PROPOSED DISTRICT CHANGE NUMBER 2:

MT LYFORD VILLAGE

Report and recommendations to the Council by Commissioner Dean Chrystal

Mt Lyford Slope Assessment Area

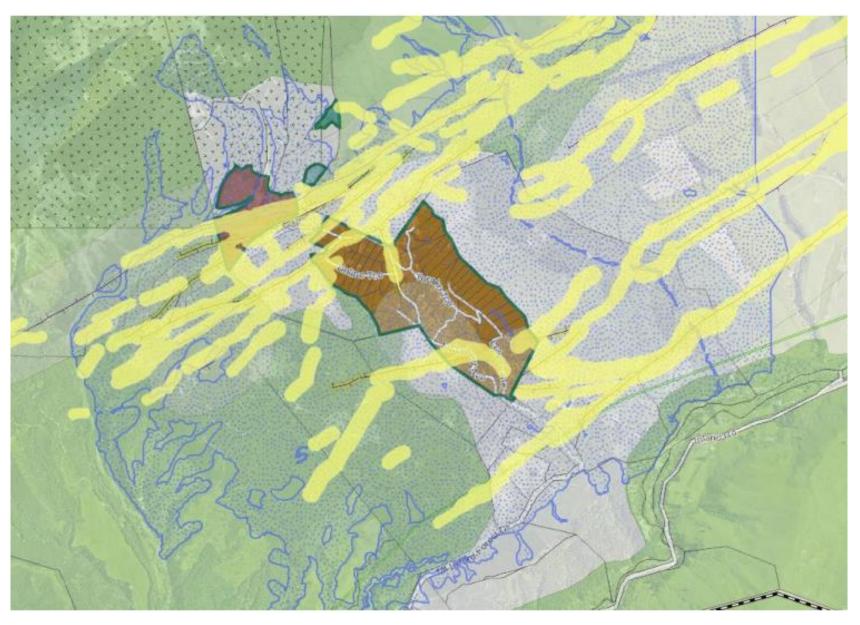
11.2.f.2	Claudine Barnes	Lighting	support		Accept
11.3		Chris June	Chapter 15	Support	No Change	Accept
12.1		Canterbury Regional Council	Mapping	Support with amendments	Retain proposed Fault Avoidance Zones - Mt Lyford Faults, and Slope Assessment Areas - Mt Lyford Slope Assessment Area, as notified in the planning maps (ePlan). Amend the planning map ePlan legends to refer to Mt Lyford Slope Assessment Area. Amend the legend in the planning map ePlan to use different symbology to identify the Mt Lyford Slope Assessment to that already in use to identify the Flood Assessment Zone.	Accept

Amend Planning Map to include Slope Assessment Area
